**SUNDRY NOTICES AND REPORTS ON WELLS**

1. Type of Well <input checked="" type="checkbox"/> Oil Well <input type="checkbox"/> Gas Well <input type="checkbox"/> Other		5. Lease Designation and Serial No. <b>LC-028793 (c)</b>
2. Name of Operator <b>Marbob Energy Corporation</b>		6. If Indian, Allottee or Tribe Name
3. Address and Telephone No. <b>P.O. Drawer 217 Artesia, New Mexico 88210 (505)748-3303</b>		7. If Unit or CA, Agreement Designation <b>NMNM 8852SX</b>
4. Location of Well (Footage, Sec., T., R., M., or Survey Description) <b>660 FSL 1980 FWL Sec 30 T-17-S R-30-E Unit N</b>		8. Well Name and No. <b>Burch Keely Unit 194</b>
		9. API Well No. <b>30-015-20668</b>
		10. Field and Pool, or Exploratory Area <b>Grbg Jackson SR Q Grbg SA</b>
		11. County or Parish, State <b>Eddy Co., New Mexico</b>

Markab Energy Co., arctic  
Before  
Burch Kaelly Unit 1+ 194

Burch Keady Unit # 194

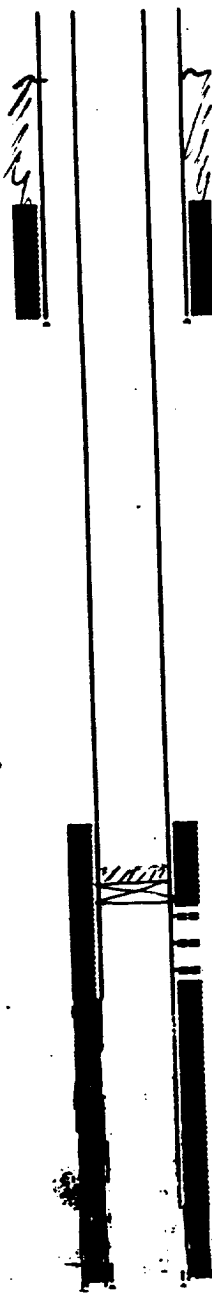
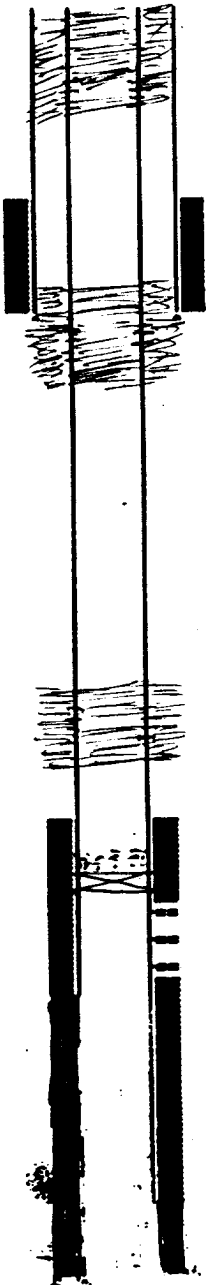
\*NOTE: ① Tag CIBP & cmt. cap @ ~2715' to establish location prior to proceeding.  
② Attempt to perforate 8 5/8" csg. @ ~100' (as well as 4 1/2" csg.) such that cement can fill 8 5/8" csg. x borehole annulus. [This step may be unnecessary if holes already exist in 8 5/8" csg] soshaw per telecon w/J Grey, Jr. 11/2/94
